Subject: Mariposa Energy Project (09-AFC-03)
Supplement A - Data Adequacy Responses

APPLICATION FOR CERTIFICATION
SUPPLEMENT A
RESPONSE TO DATA ADEQUACY REVIEW

FOR THE
Mariposa Energy Project

FIGURE DA2.0-1D
VIEW FROM SOUTHWESTERN PROJECT SITE
Mariposa Energy Project
Alameda County, California

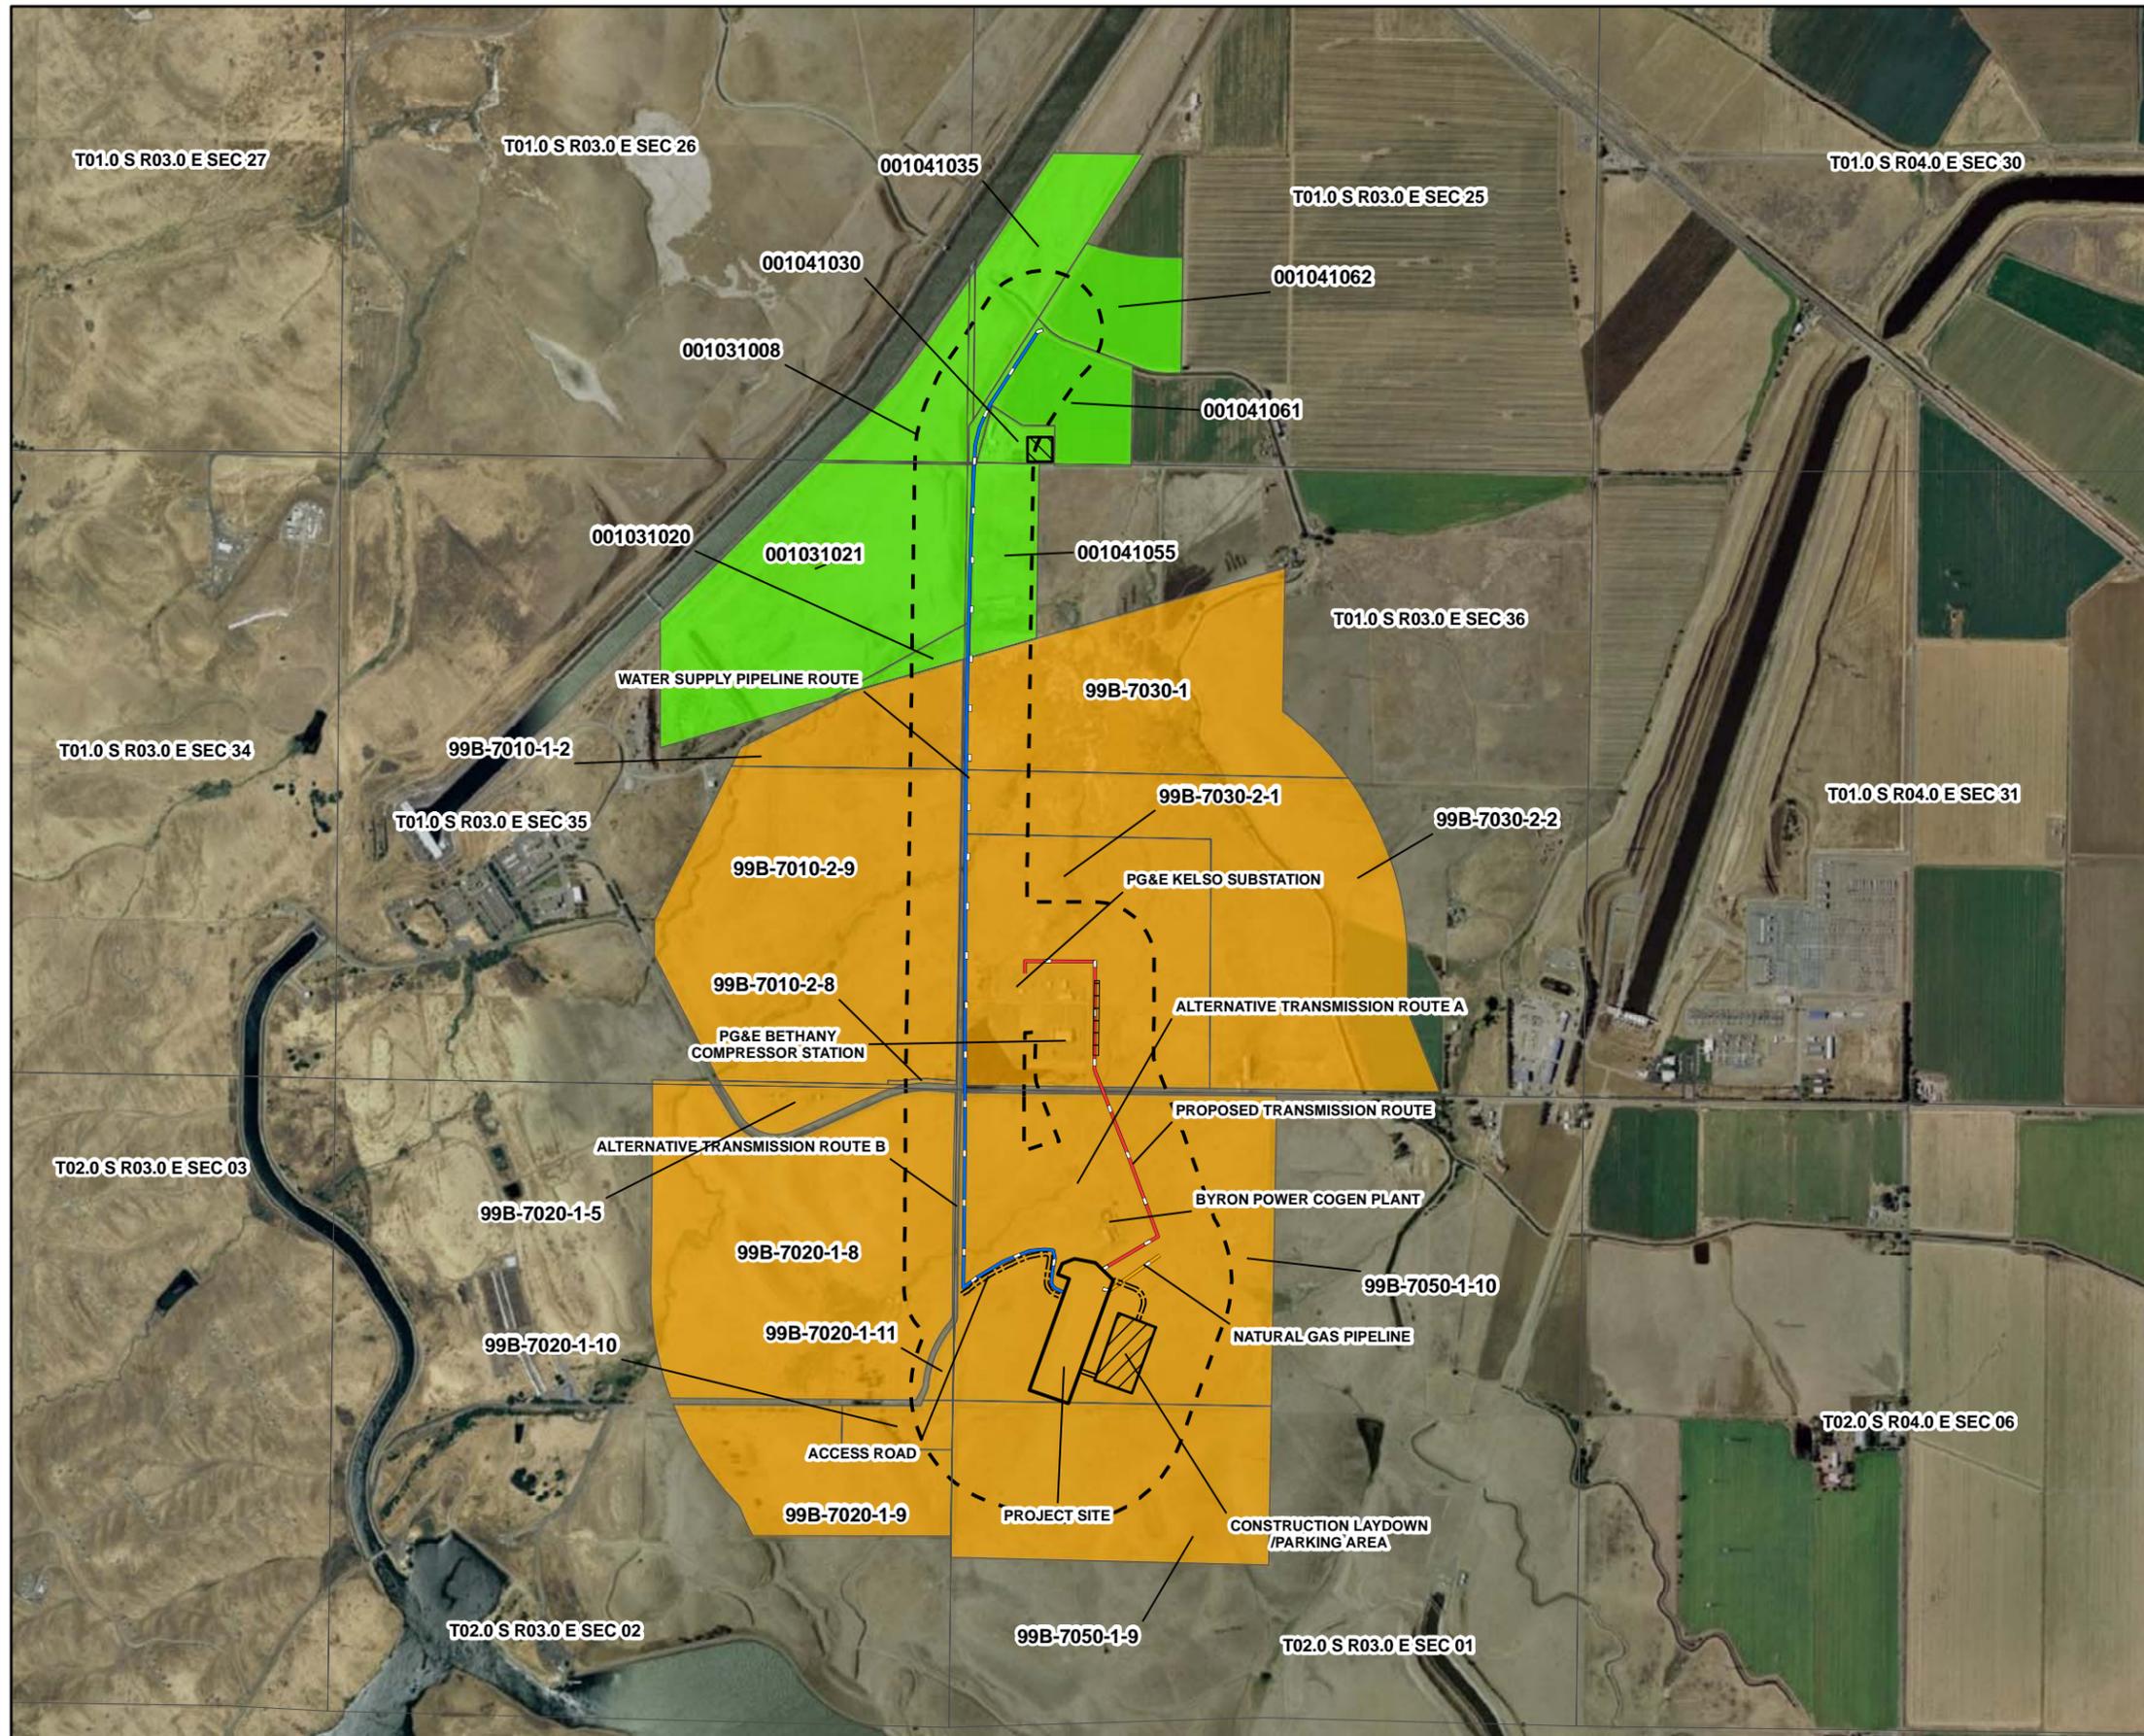
Please provide the full page color photo reproduction depicting the visual appearance of the site prior to construction.

Response: Full-page color photo reproductions depicting the current (pre-construction) site conditions are provided in Figures DA2.0-1A through DA2.0-1D.

**FIGURE 3.2-2R
TYPICAL MONOPOLE
TRANSMISSION TOWER**

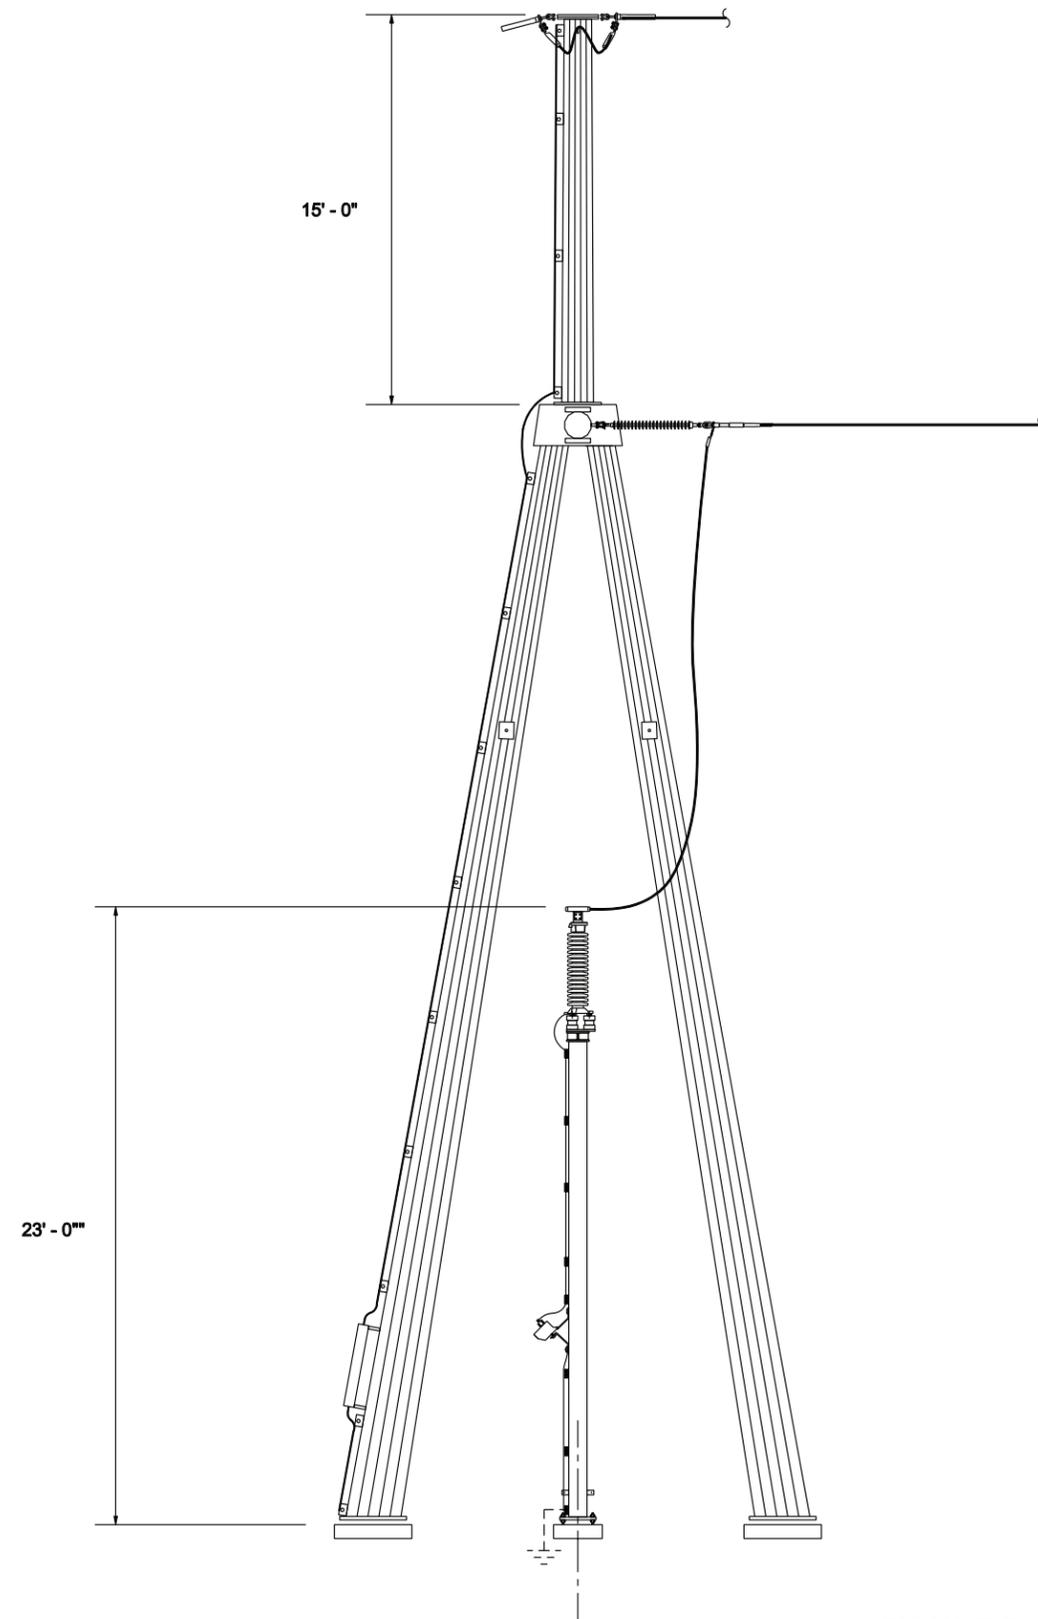
1. *Please submit Pole design diagram (or resubmit Figure 3.2-2) including dead-end structures for the 230 kV generator overhead tie line showing configuration of insulators and conductors (with sizes, type and ampere rating) with their respective position measurements on the pole.*

1. A figure identifying detailed drawings of the pole design is provided as Figure 3.2-2R, and dead structure is provided as Figure DA3.0-1.
2. A revised single-line diagram showing the sizes and ratings of switchyard equipment and the plant is provided as Figure 2.3-4R.
3. Mariposa Energy has submitted requests to PG&E for pre-project and post-project electrical one-line drawings for the Kelso 230 kV Substation. Based on the e-mail response (Attachment DA3.0-1) from Barbara Madrid, Senior Project Manager for Generation Interconnection Services, PG&E will only provide simplified pre-project and post-project one-line diagrams at this time, stating that additional detail will be available

FIGURE 2.3-4R
FACILITY SINGLE LINE DIAGRAM
 Mariposa Energy Project
 Alameda County, California

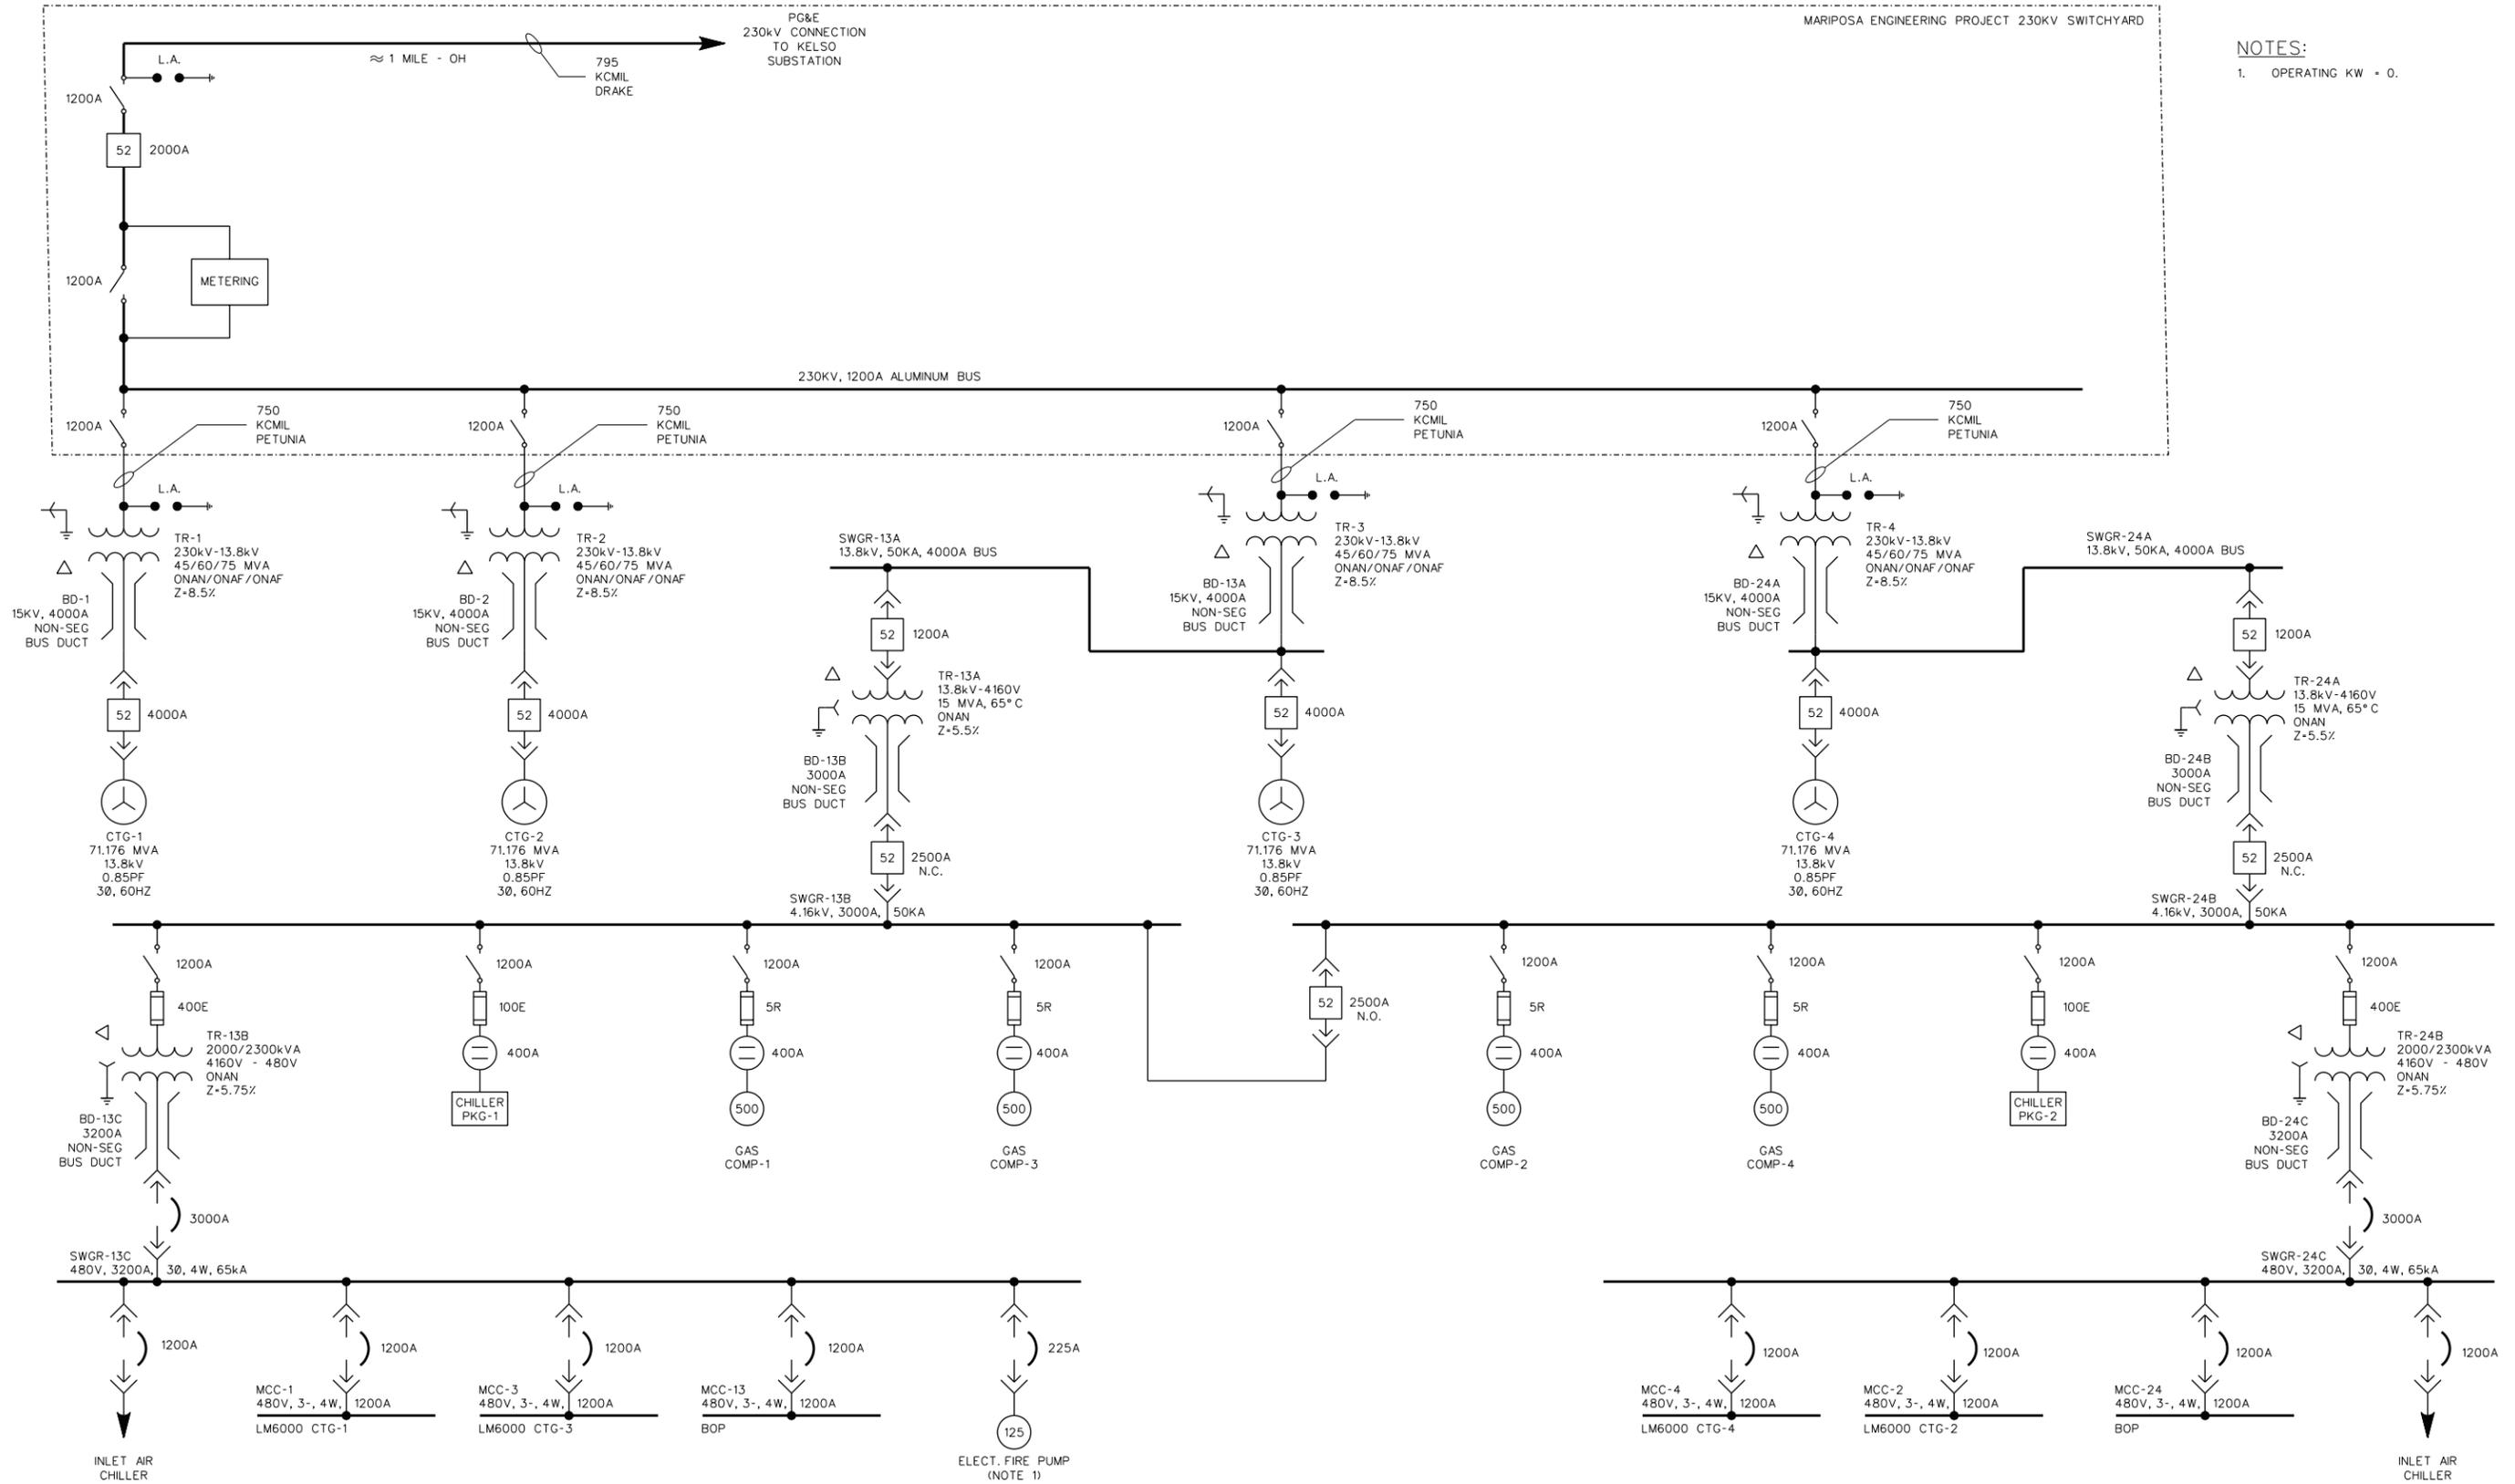
2. *Please submit a complete electrical one-line diagram (or resubmit Figure 2.3-4 with missing elements or sizes/ratings) of the proposed MEP 230 kV switchyard showing all equipment for all new generators' interconnection with the switchyard along with their respective sizes and/or ratings as follows: i) Any bus duct connectors or overhead conductors or cables, 13.8 kV switchgear, buses, breakers & disconnect switches on the low side of each Generator step-up transformer (GSU); and ii) The GSU and short overhead conductors and/or cables from the GSU to the switchyard with the configuration for the switchyard buses, breakers, disconnect switches on the 230 kV side, along with the proposed tie line transmission outlet from the switchyard.*
